TRANS/WP.29/GRE/2004/28  
19 July 2004

World Forum for Harmonization of Vehicle Regulations (WP.29)

PROPOSAL FOR DRAFT AMENDMENTS TO REGULATION No. 48  
(Installation of lighting and light-signalling devices)

Transmitted by the Informal Group "Adaptive Front-lighting Systems (AFS)"

Apparent surfaces of lighting units 1 through 11 of an AFS (example)

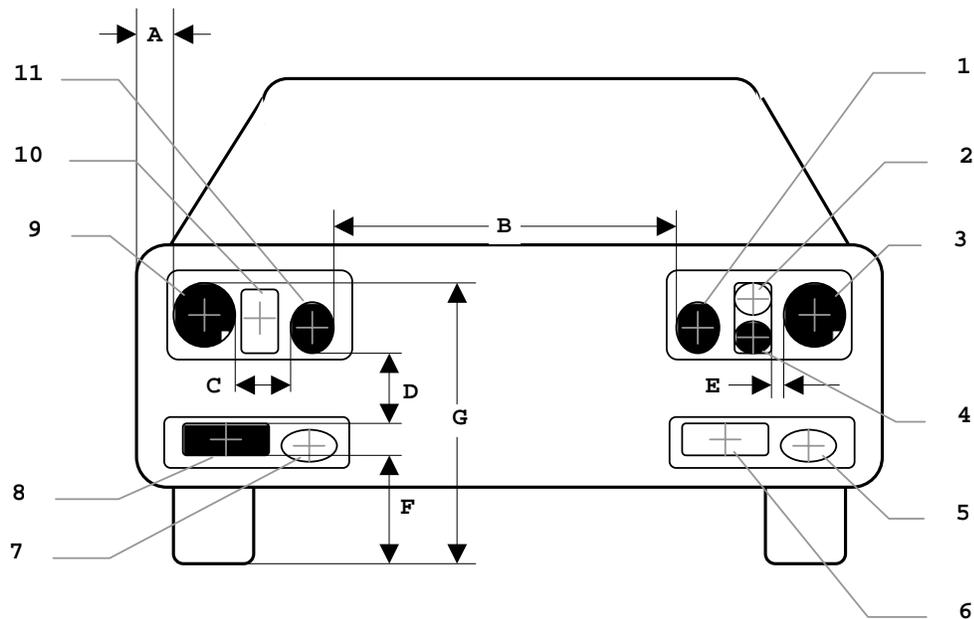
**6.22.4.1.1.** Two symmetrically placed lighting units shall be positioned at a height in compliance with the requirements of the relevant paragraphs 6.1.4. and 6.2.4., where "Two symmetrically placed lighting units" shall be understood to be two lighting units, one on each side of the vehicle, positioned such that the (geometric) centres of gravity of their apparent surfaces are at the same height and at the same distance from the vehicle's longitudinal median plane within a tolerance of 50 mm, each; their light emitting surfaces, illuminating surfaces, and light outputs, however, may differ.

**6.22.4.1.2.** Additional lighting units, if any, on either side of the vehicle shall be positioned at a distance not exceeding 140 mm 7/ in horizontal direction (E in the figure) and 400 mm in vertical direction above or below (D in the figure) from the nearest lighting unit;

**6.22.4.1.3.** None of the additional lighting units described in paragraph 6.22.4.1.2. above shall be positioned lower than 250 mm (F in the figure) nor higher than 1200 mm (G in the figure) above the ground;

the outer edge of the apparent surface of at least one lighting unit on each side of the vehicle shall not be more than 400 mm from the extreme outer edge of the vehicle (A in the figure); and,

the inner edges of the apparent surfaces in the direction of the reference axes shall be not less than 600 mm apart. This does not apply, however, for M<sub>1</sub> and N<sub>1</sub> category vehicles; for all other categories of motor vehicles this distance may be reduced to 400 mm where the overall width of the vehicle is less than 1300 mm."

7/ In case of additional "two symmetrically placed lighting units" the horizontal distance may be 200 mm (C in the figure).

- $A \leq 400$
- $B \geq 600$ , or,  $\geq 400$  if vehicle overall width  $< 1300$  mm, however  
no requirement for category M1 and N1 vehicles
- $C \leq 200$
- $E \leq 140$

- $D \leq 400$
- $F \geq 250$
- $G \leq 1200$
